**RE: Curia Building Addition
34401 Alexander Blvd. NE Albuquerque, NM 87107
Grading and Drainage Plan (F16D003B1)
Engineers Stamp Date 10/25/2022**

Re: Curia Building Addition
4401 Alexander Blvd NE Albuquerque, NM 87107
Grading and Drainage Plan (F16D003B1)
Letter of Response

RE: **Oso Bio Syringe Line**
4401 Alexander Blvd NE
Grading and Drainage Plan for Building Permit
Engineer's Stamp Date 11/1/2018 Disapproved
Hydrology File: F16D003B1

Re: Oso Bio Syringe Line Grading Plan Submittal; Hydrology File F16D003B1

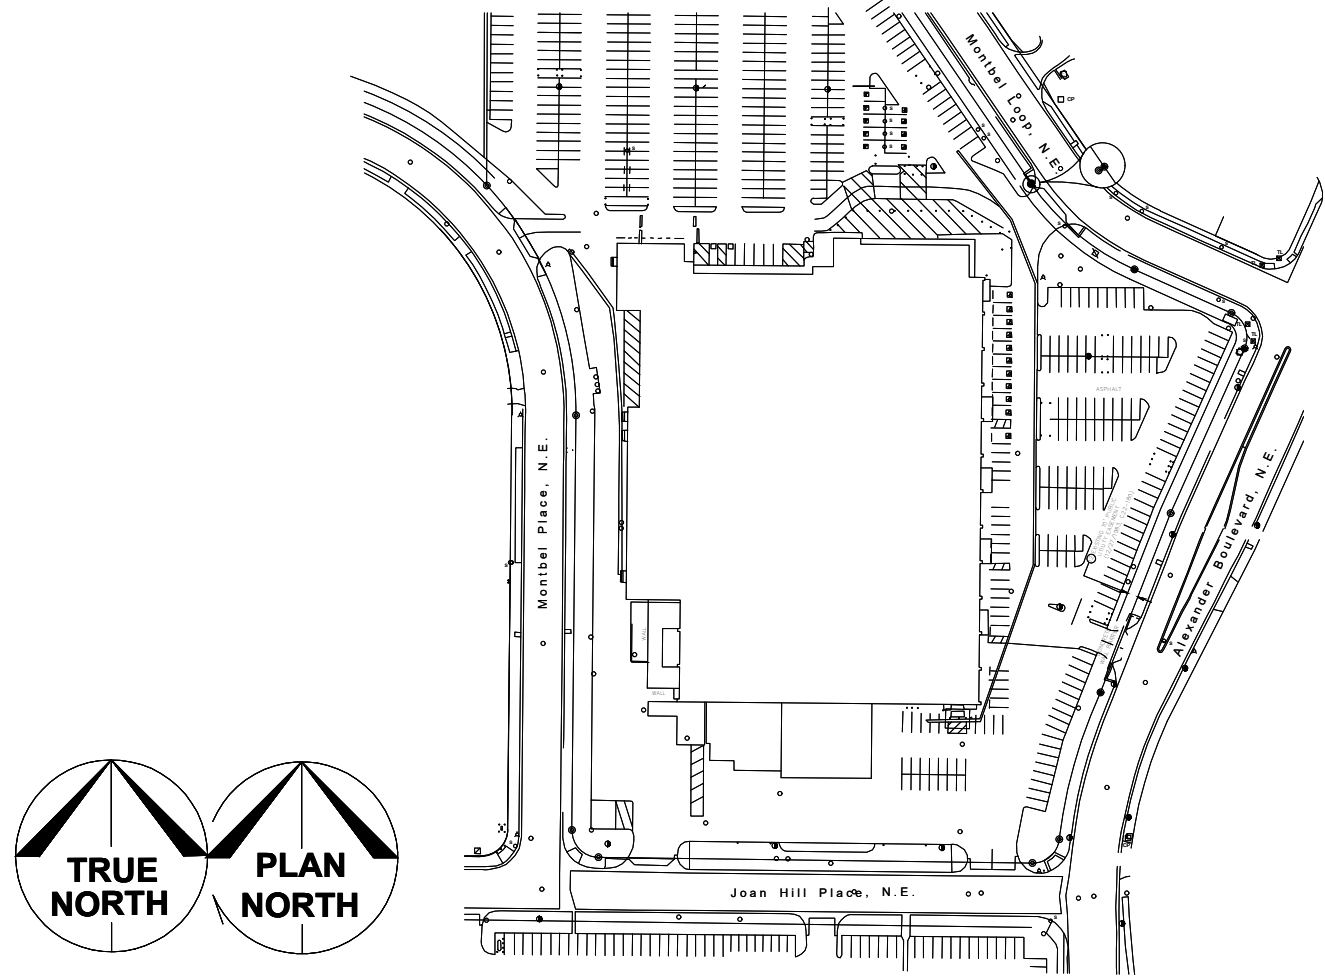
- 5) First Flush Volume requirement calculations must be provided. How will the first flush volume requirement be handled?
First Flush Volume calculations are included in CG101 Overall Grading & Drainage Plan. The existing / proposed detention pond retains the First Flush within

the volume from bottom of pipe to bottom of pond.

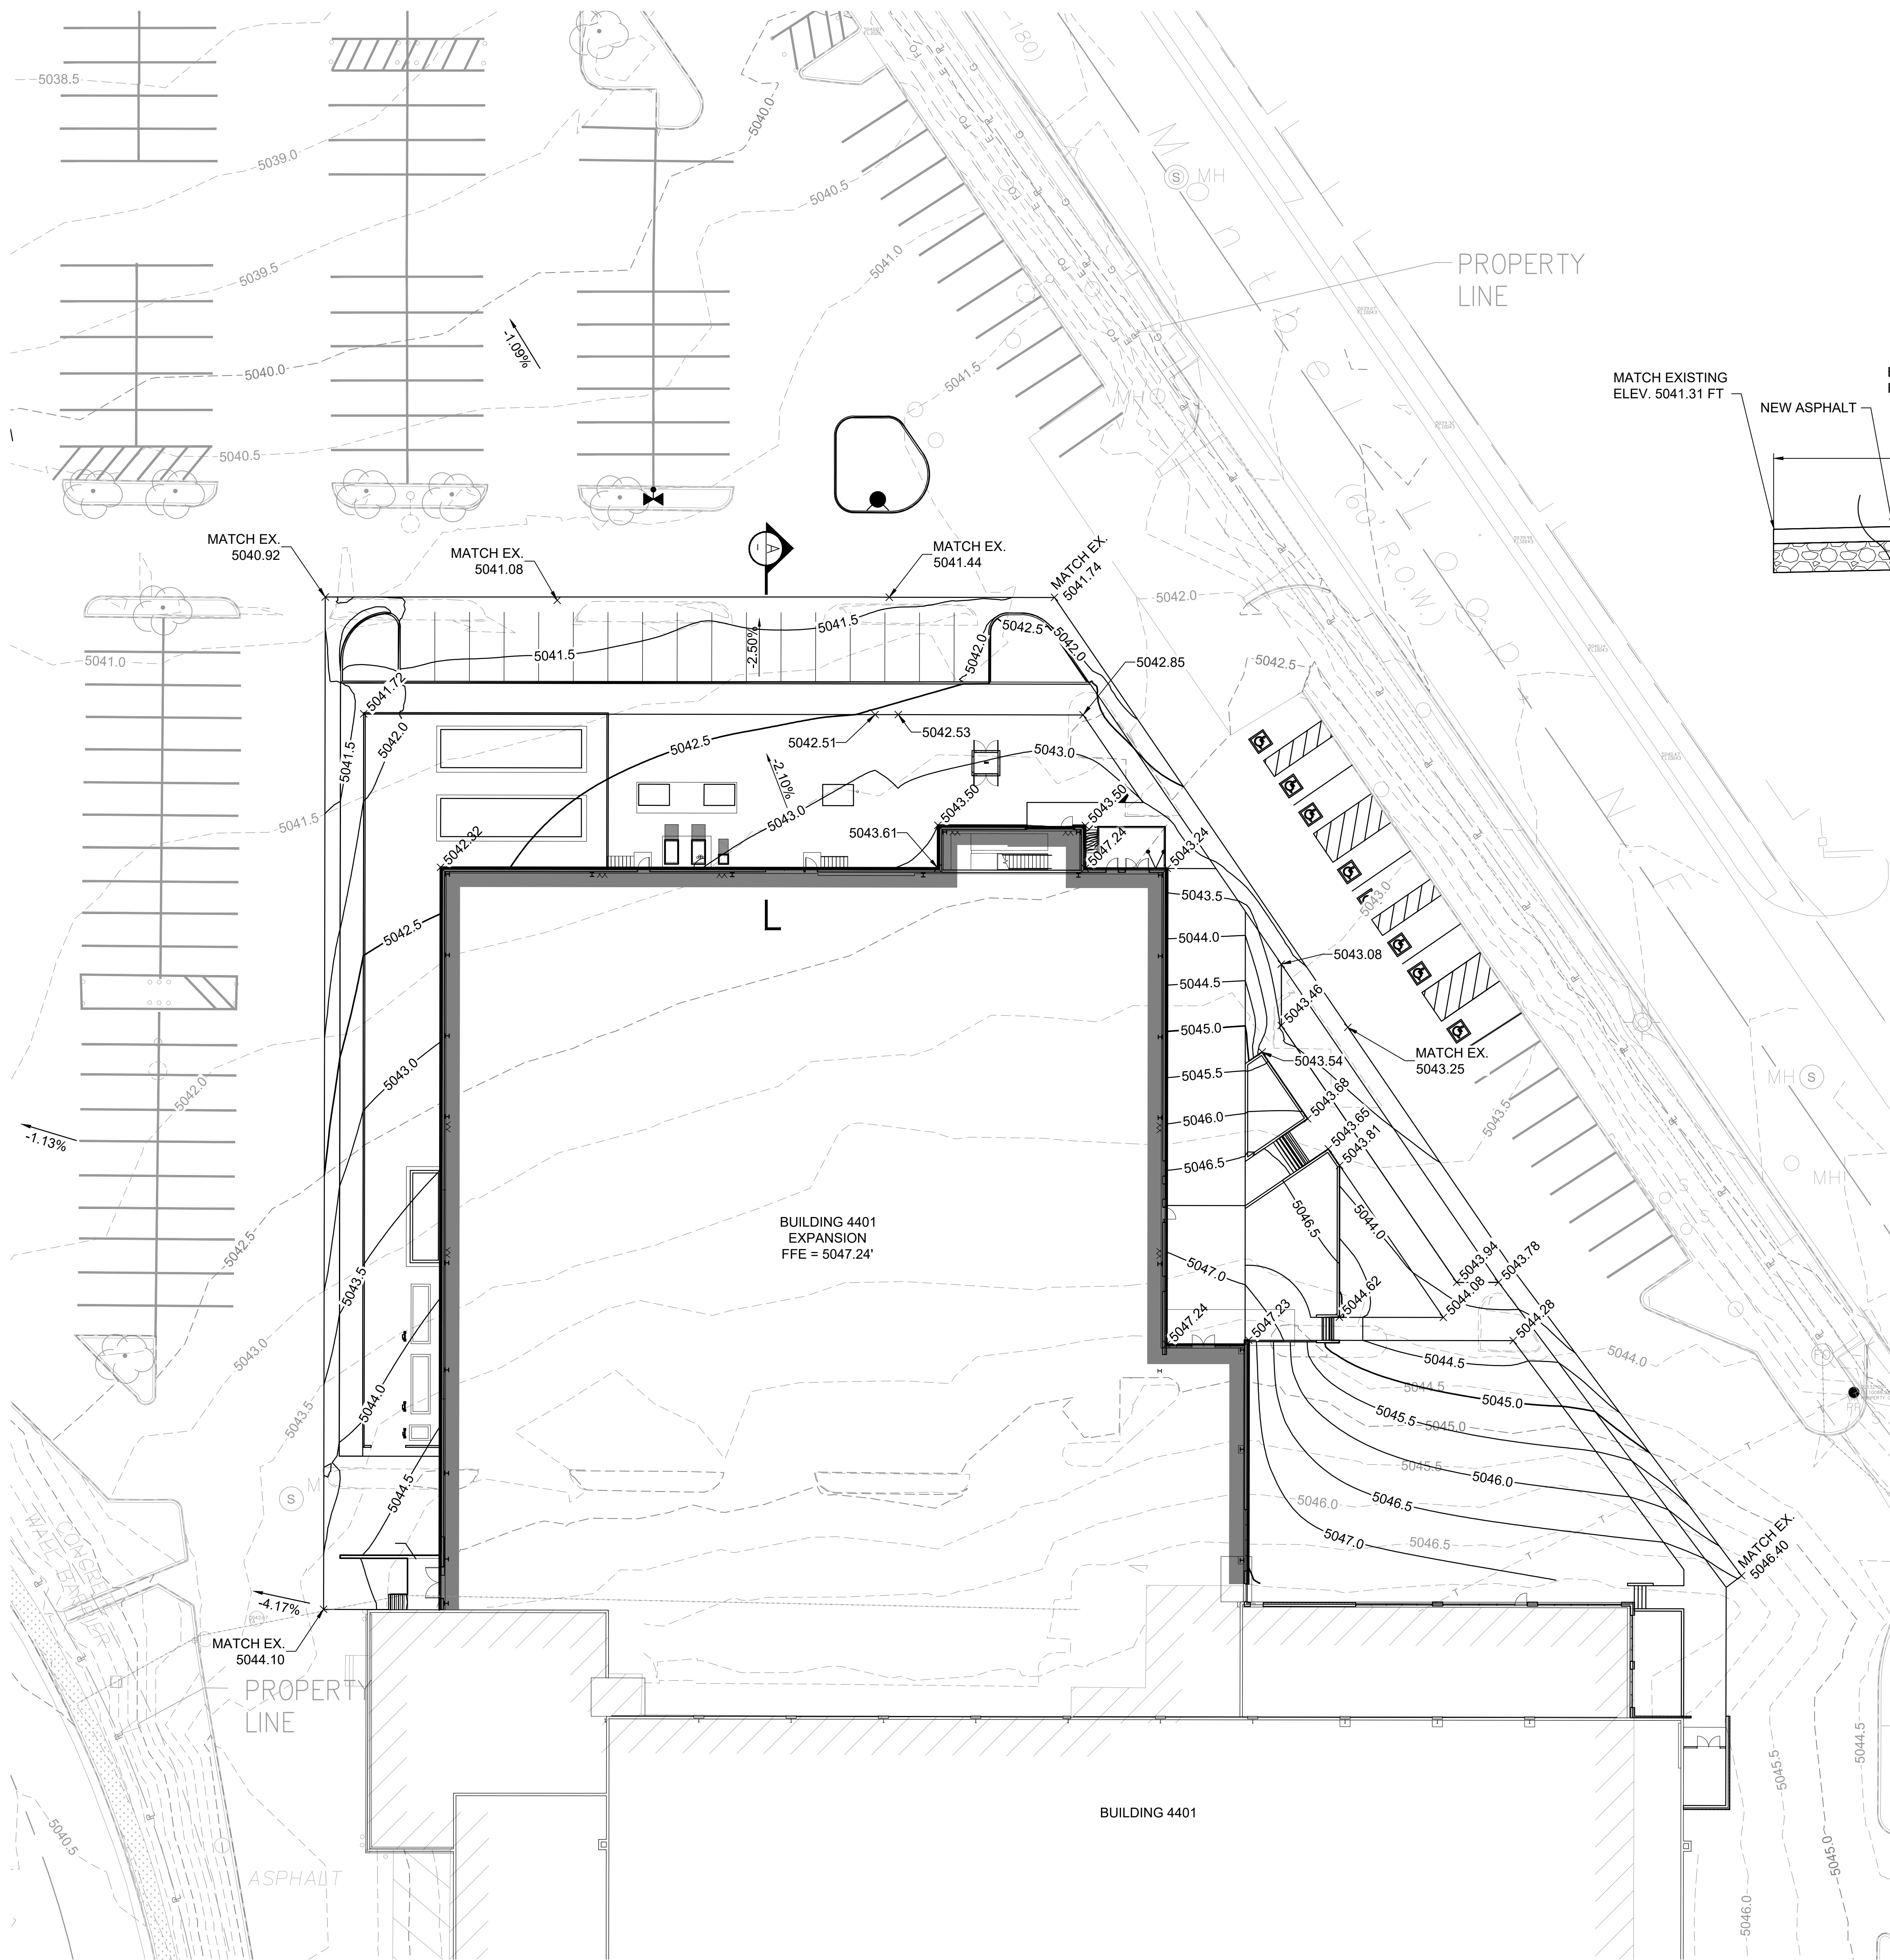
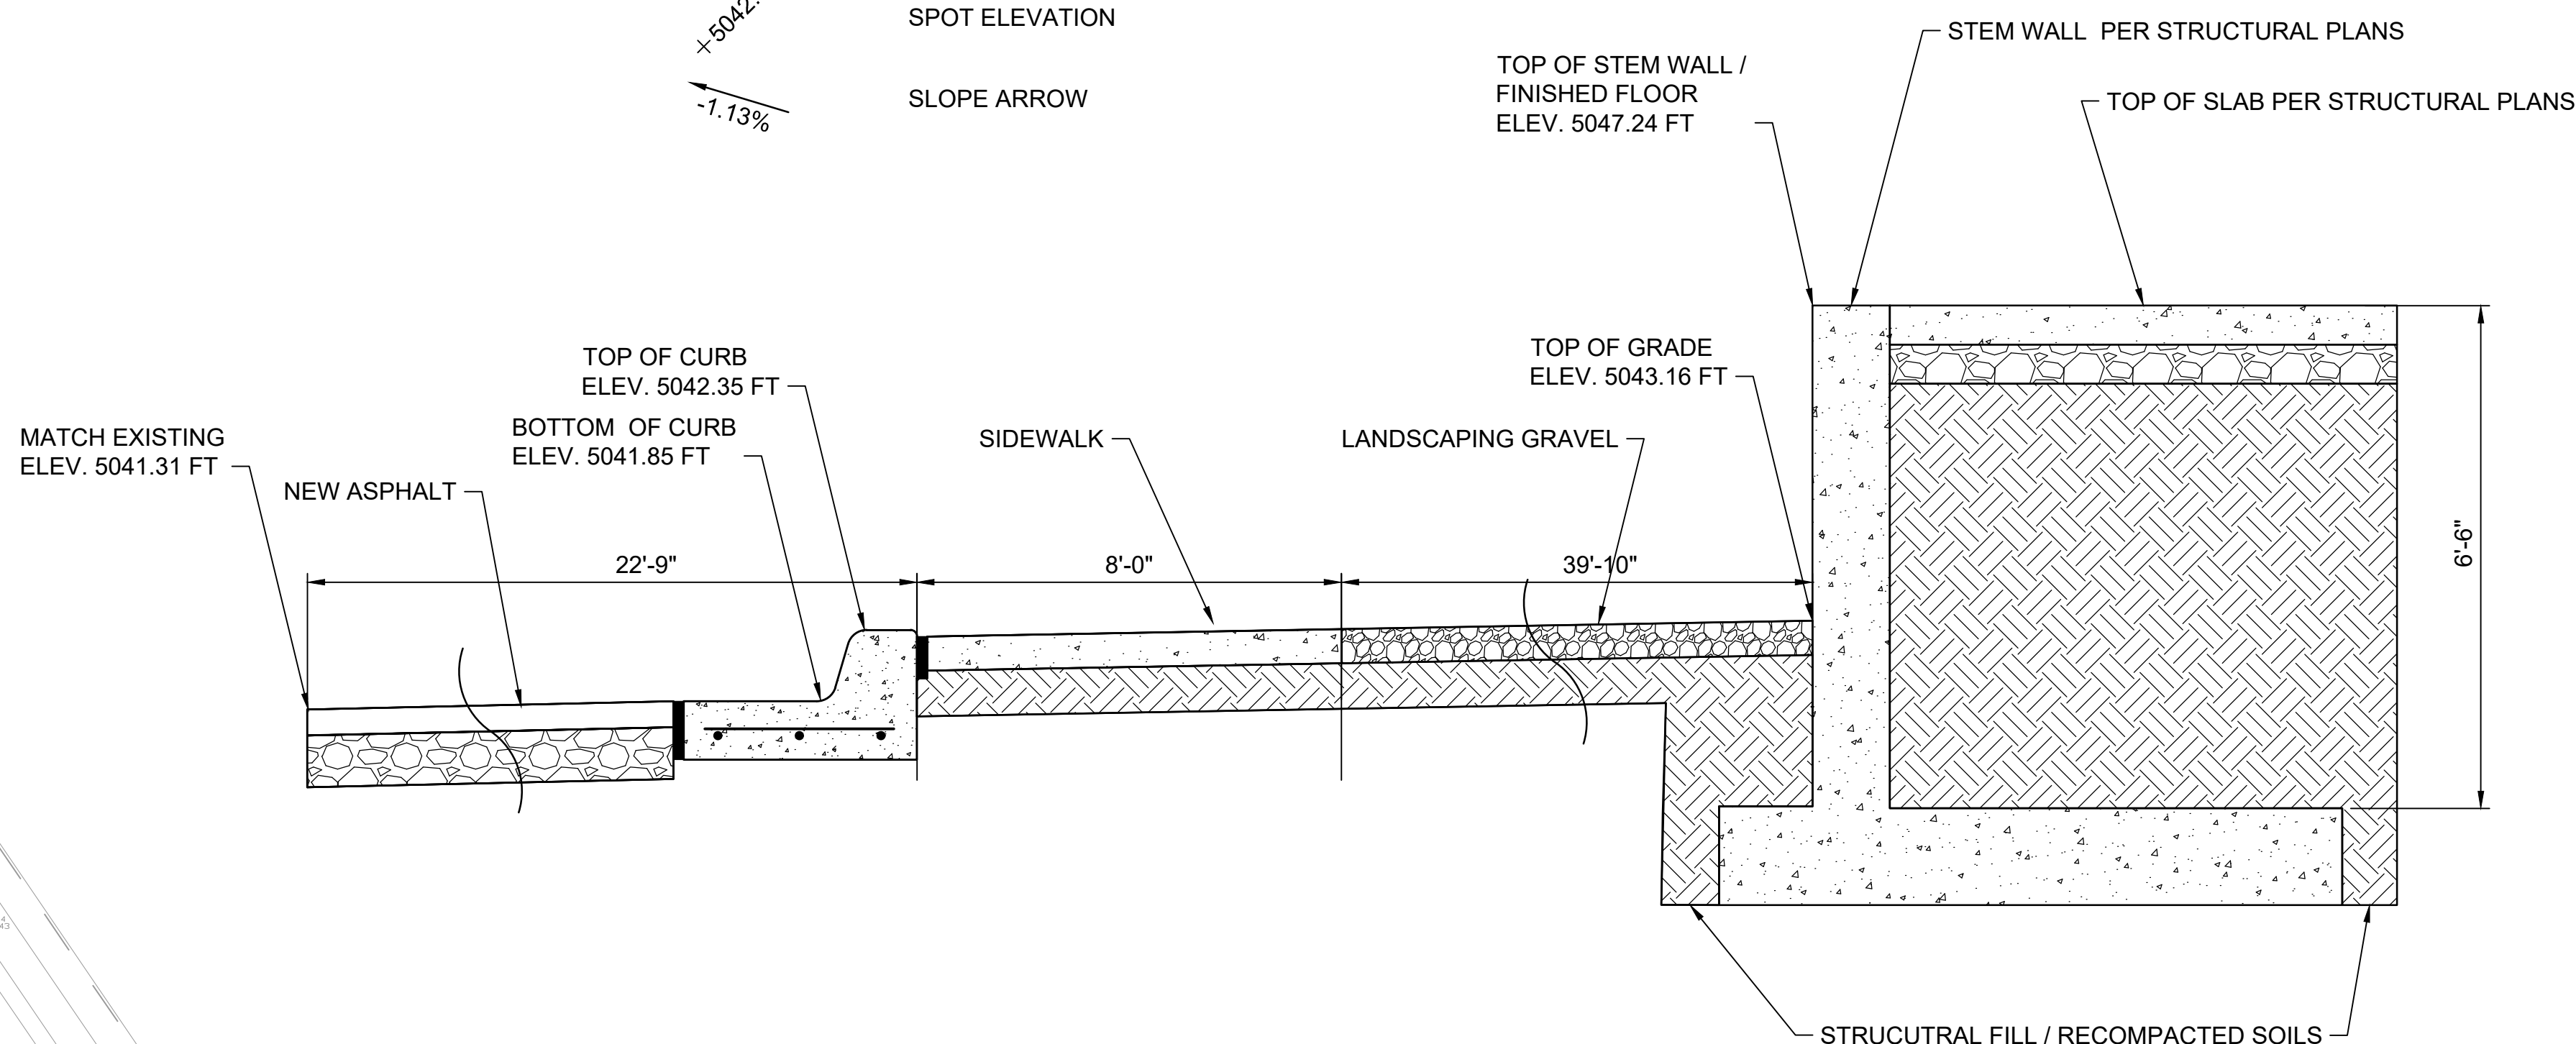
- 4) Provide detail elevation and finished contours around the building and beyond to show how it will tie to the existing grades. To the north the Finished Floor elevation is nearly 6' about the exiting grade. Are there going to be stem walls. Provide cross-sections.
Finish grade and cross section are included on drawing CG102 Enlarged Grading & Drainage Plan.
